Oxford Flood Alleviation Scheme: assessment of impacts on species-rich floodplain meadow habitat

March 2018

Figure 1. Soil-moisture-release curve for the upper soil horizon of Hinksey Meadow. The curve represents the mean values from six separate cores (sampled from across the meadow,) which were analysed on a sand-table. The error bars represent one standard error of the mean.

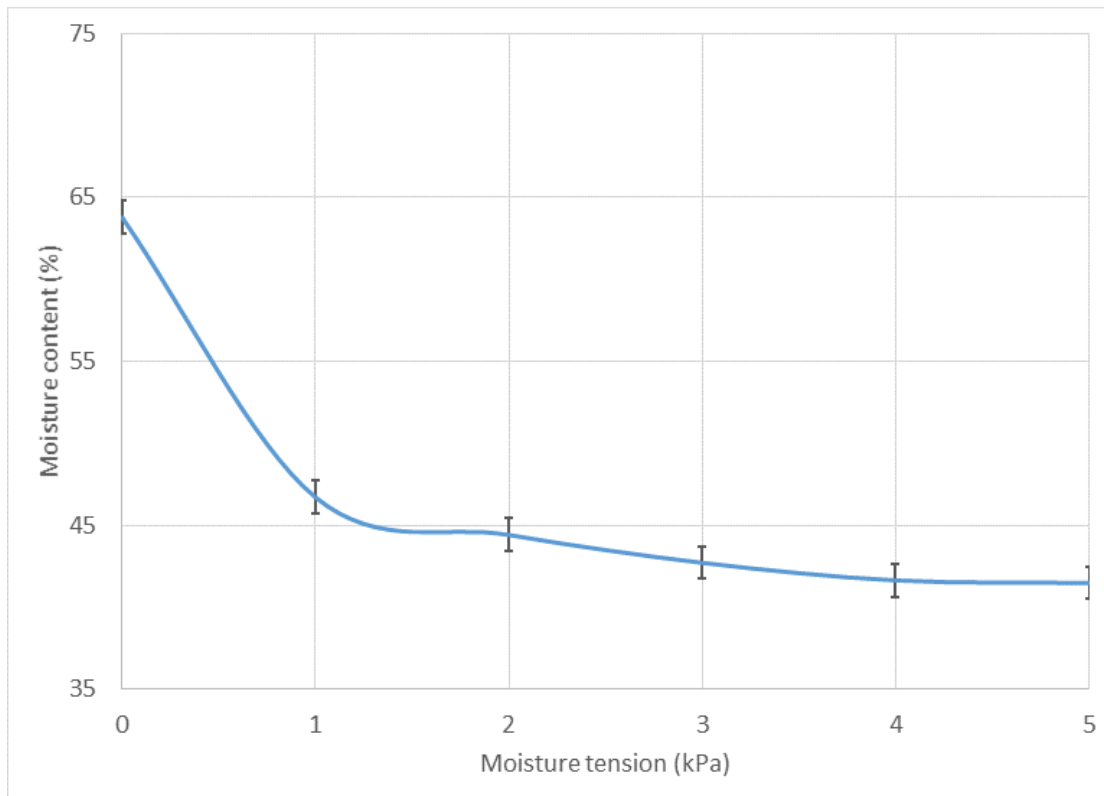
There is unlikely to be a discontinuity because the alluvium is relatively shallow (<1 m deep) at the site and its soil-moisture release curve shows it to be very well structured. It is therefore likely that the root zone will be directly affected by any change to the piezometric head in the gravel aquifer.

From the 2016 NVC map supplied by Dr. T. King, the vegetation has been classed as subcommunity type a, which is the driest variant of the MG4 community, suggesting the current soil moisture conditions are at the dry end of the water-regime range typified by that community. If ground-surface elevation data for the modelled positions (OS1 and OS5) are available, we could calculate absolute measures of the water regime at those locations based on the model output and make a more definitive statement about where the site falls within the tolerance range.

Fig 1a: water level and management requirements for creation of MG4 community

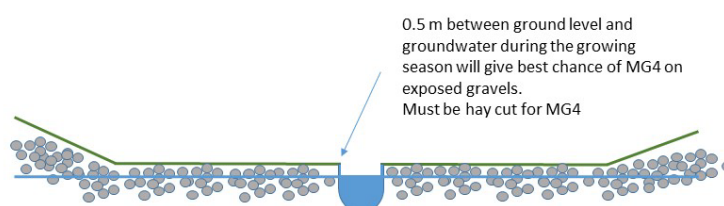
1. a thin (<1.5 m) layer of alluvium over gravel
2. a depth to groundwater is generally in the range 0.5 - 1.0 m during the hay growing season (March-June)(March to June) when above-ground competition between species is at its greatest.

1. If the objective is to create MG4 and particularly if turfs from Hinksey Meadow are to be used in the upper channel, then it is essential that the two-stage channel has an annual hay cut. Aftermath grazing is desirable but not essential, if replaced by a second hay cut in September when the re- growth warrants it. Arisings should be removed after each cut. This latter scenario would obviate the need for fencing along the channel or between ownerships.
2. If the objective is to create wet-grassland habitat, but not specifically MG4, and particularly if MG8 or MG13 were more suited to the hydrological regime, then management through grazing alone would be an option. These communities can exist as either meadow or pasture.

Fig 1b: water level and management requirements for creation of MG8 community

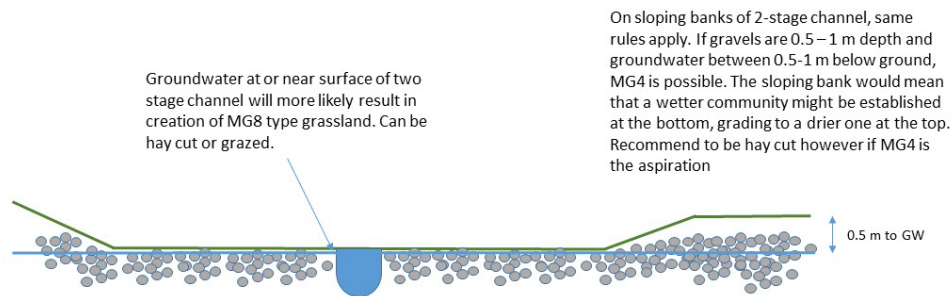
If the depth to groundwater is shallower than 0.5 m and/or the low-flow channel is to be kept at bankfull, then it is likely that a wetter community will develop, for example MG8.
